**Public Works Committee Meeting**  
**Tuesday, February 16, 2021 5:00 PM**  
**Crete Library/Community Center**  
**1515 Forest Ave.**  
**Crete, NE 68333**

- The Committee may discuss or limit discussion on, hear testimony in favor of or in opposition to, or take action to provide a recommendation to the City Council on any matter presented under this title.
  - A. Discuss locations of sidewalks on gap paving projects.
  - B. Discuss authorizing plans and specifications for water remediation project.
  - C. Discuss State Revolving Fund on West side water main and water well project.

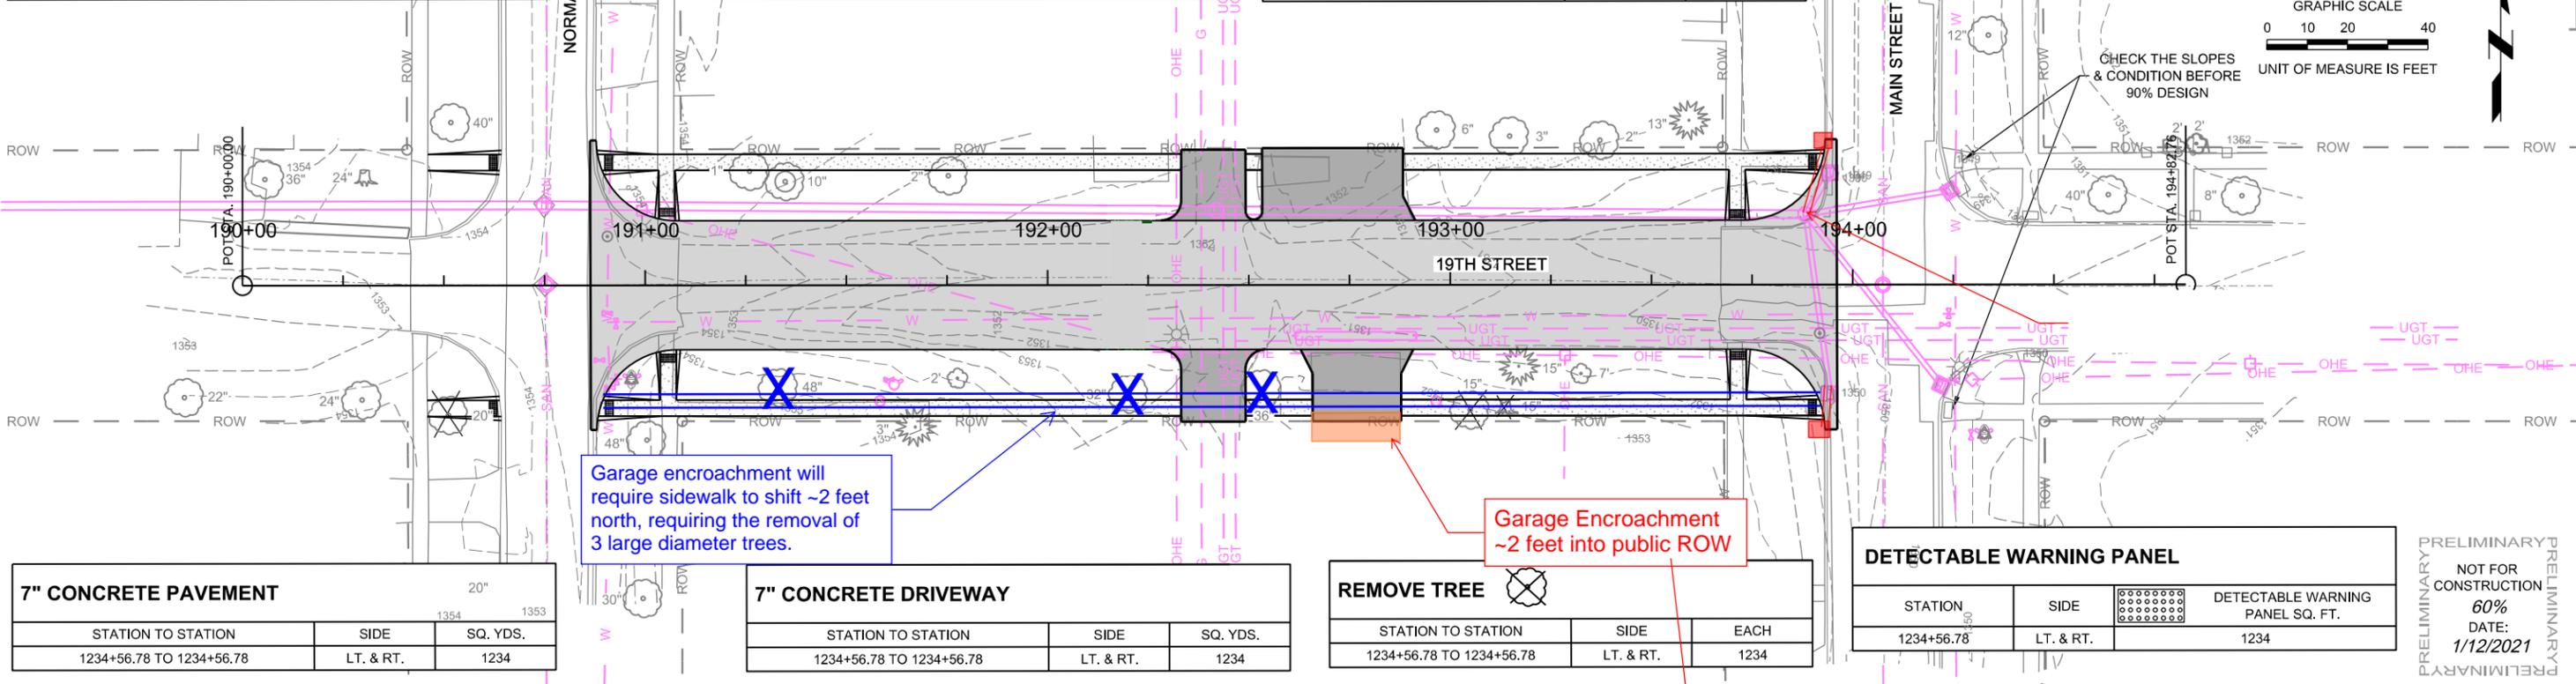
Tree will need to be removed to shift sidewalk north to avoid encroaching garage.

Additional tree removals will increase project cost by ~\$2,500

Tree will need to be removed to shift sidewalk north to avoid encroaching garage.

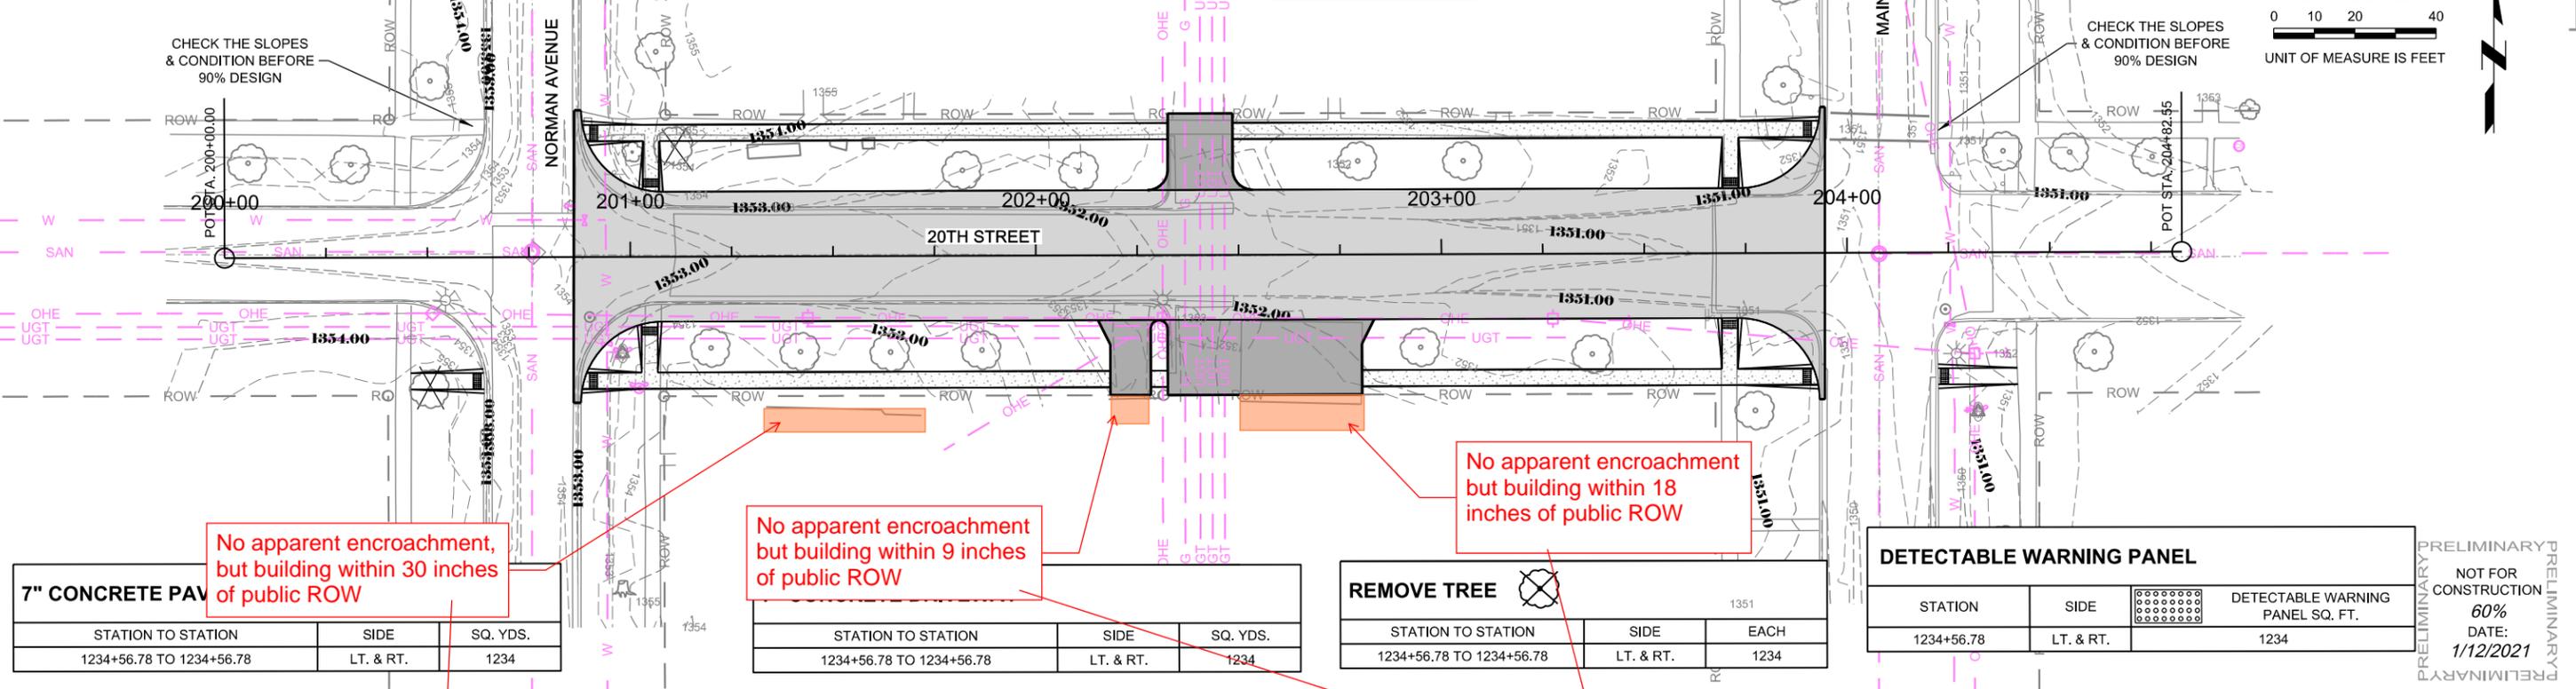
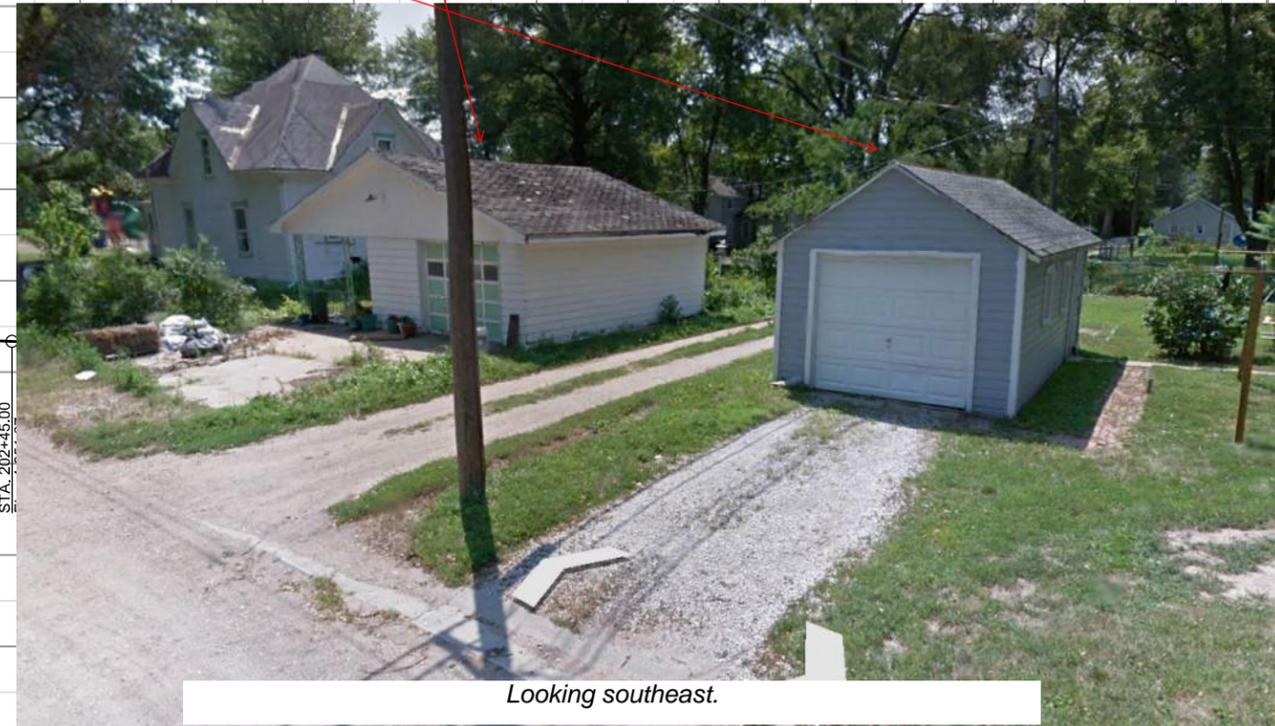
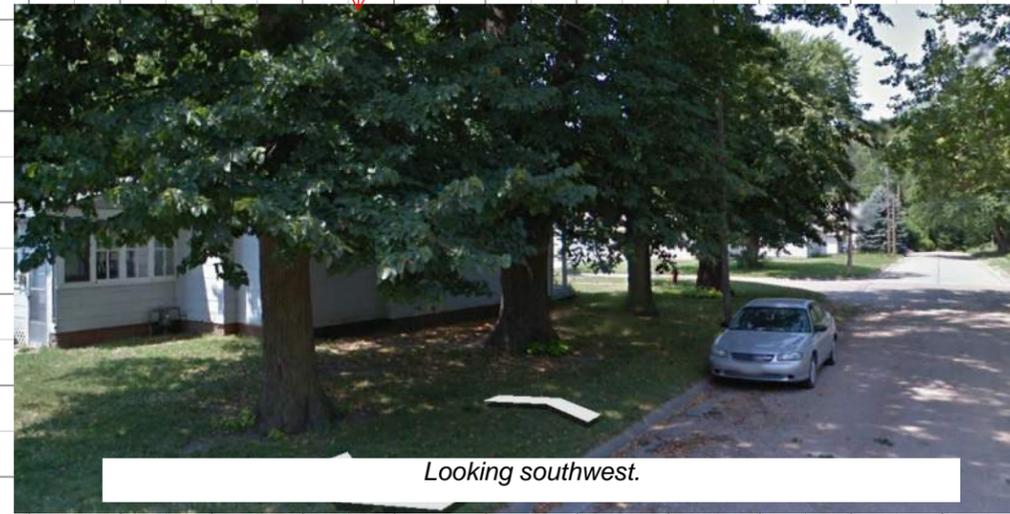
No apparent encroachment, but building within 30 inches of public ROW

No apparent encroachment but building within 9 inches of public ROW

No apparent encroachment but building within 18 inches of public ROW

Sidewalk can stay as preliminarily designed, yet will reside close to existing garages.

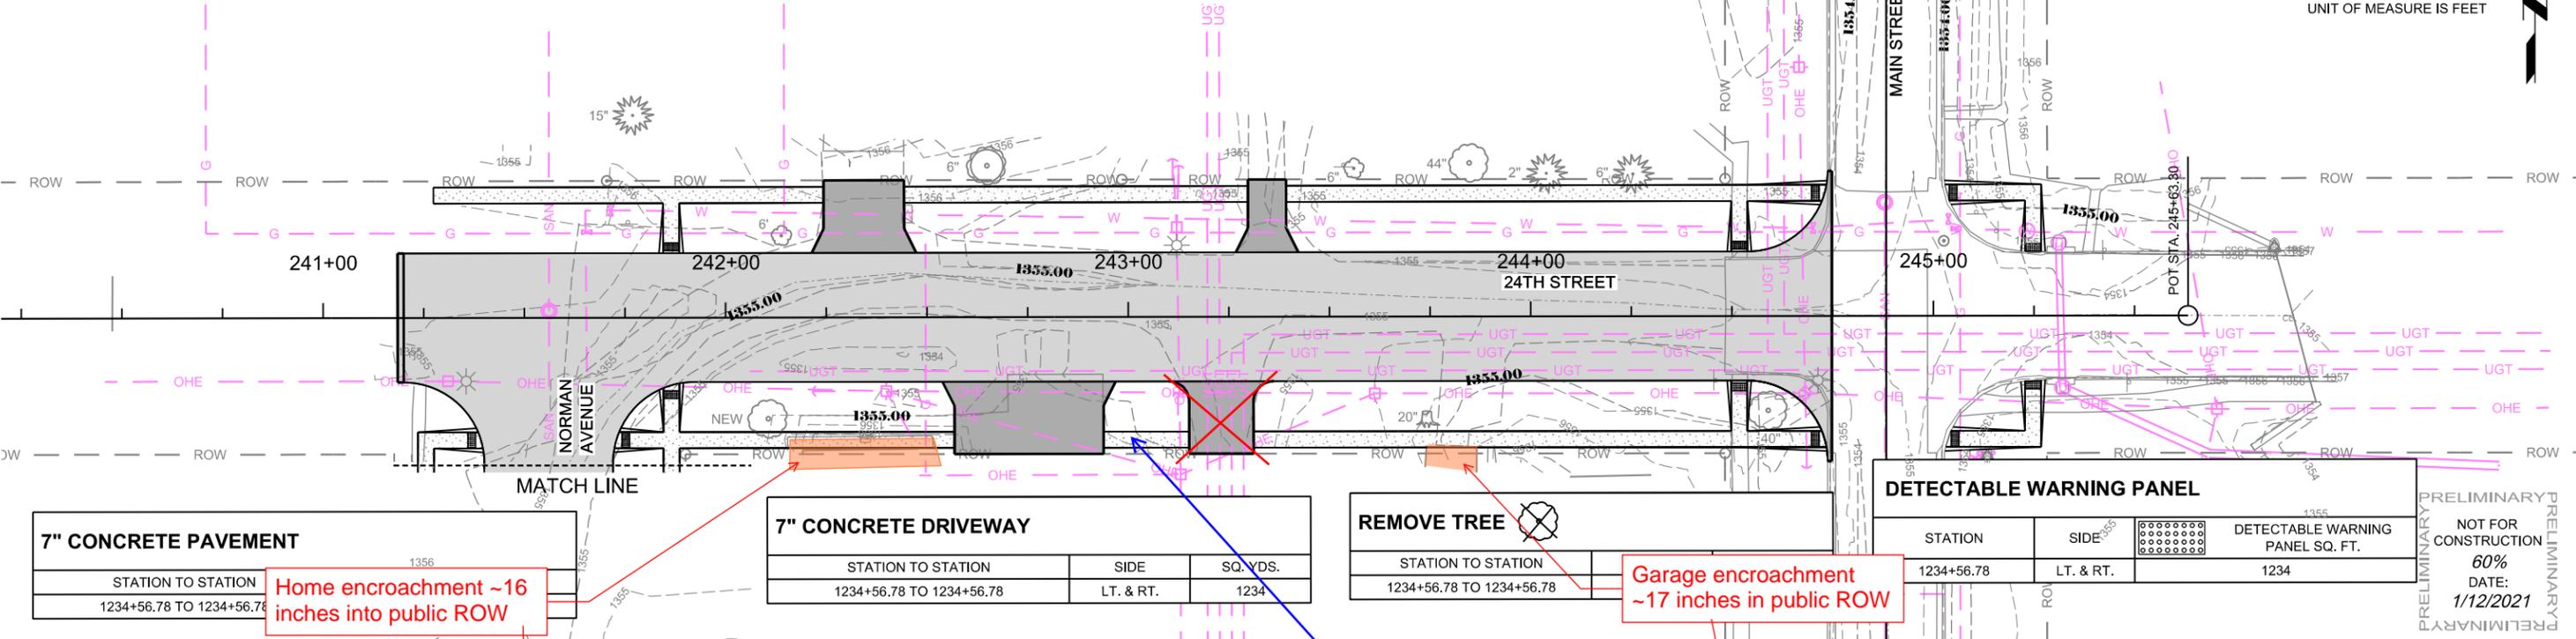
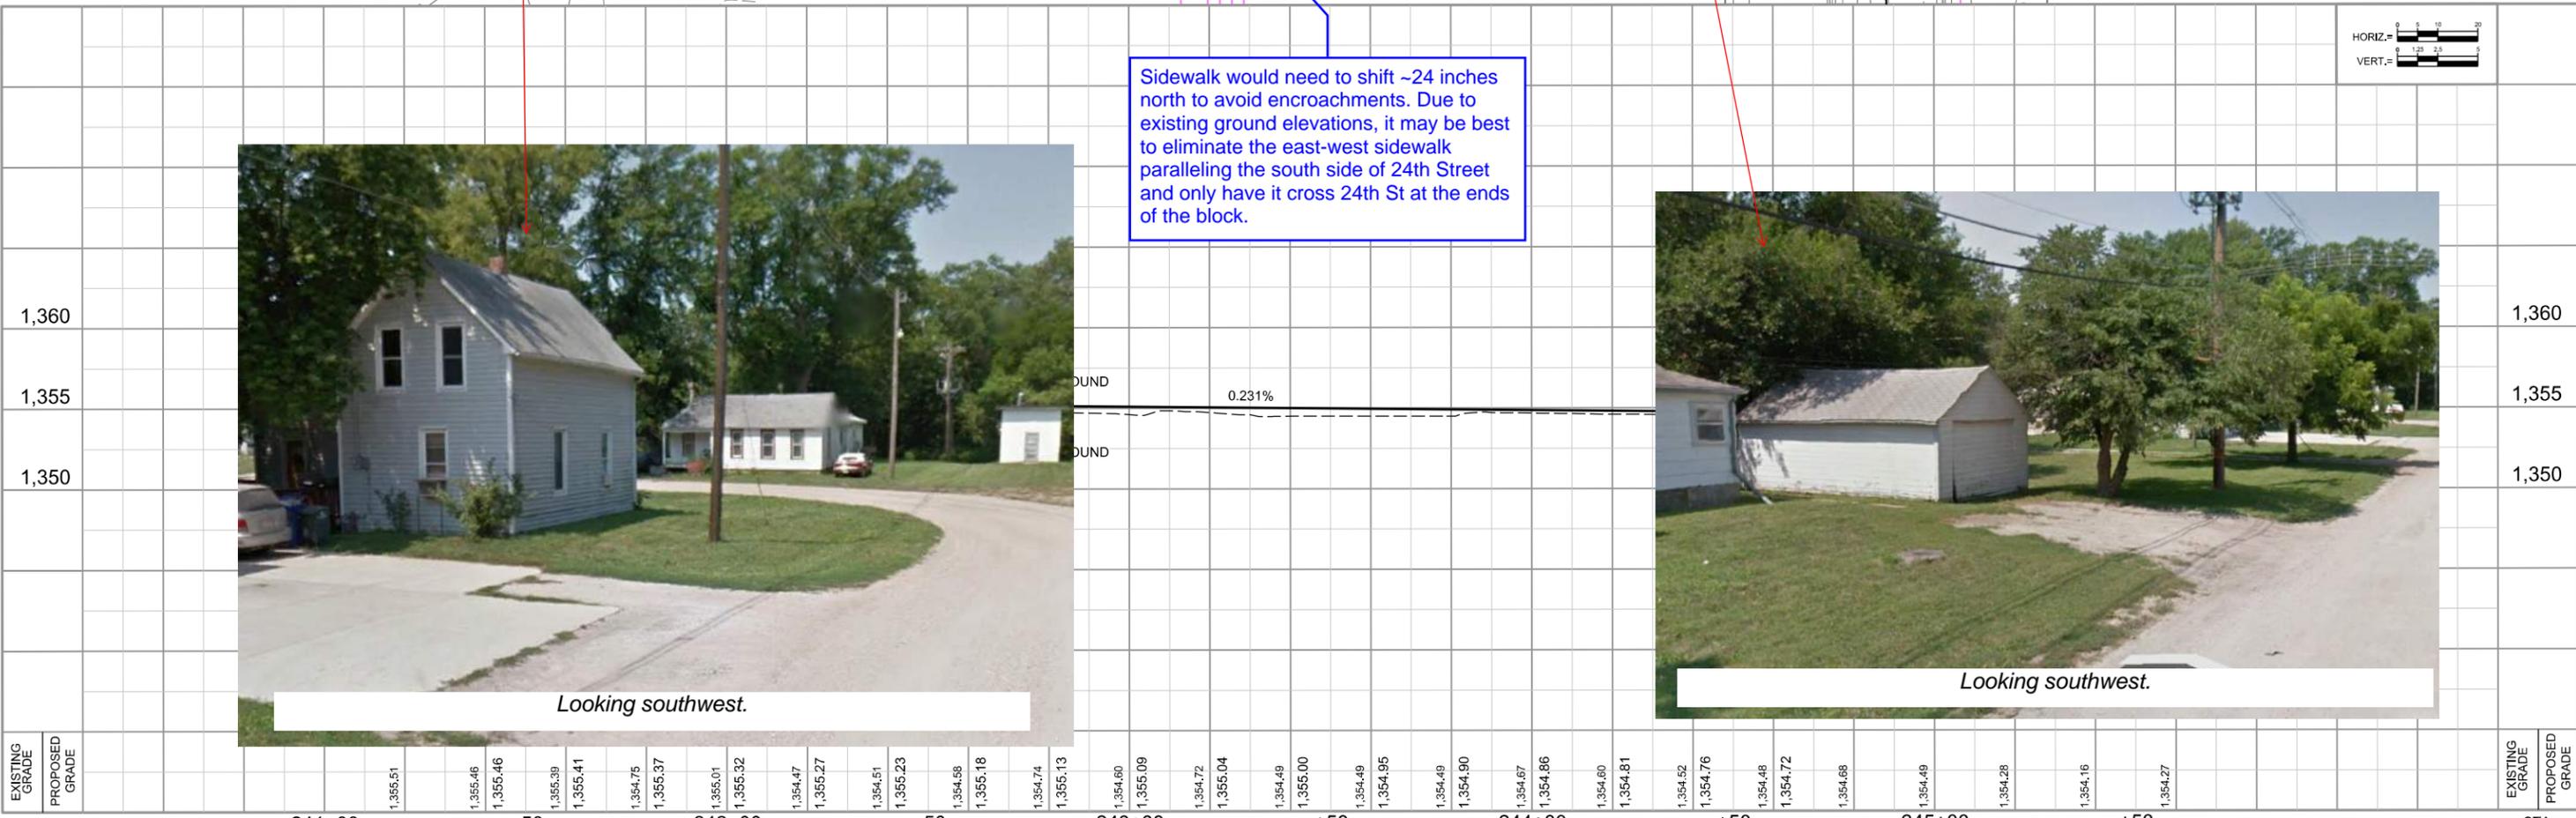
Home encroachment ~16 inches into public ROW

Garage encroachment ~17 inches in public ROW

Sidewalk would need to shift ~24 inches north to avoid encroachments. Due to existing ground elevations, it may be best to eliminate the east-west sidewalk paralleling the south side of 24th Street and only have it cross 24th St at the ends of the block.
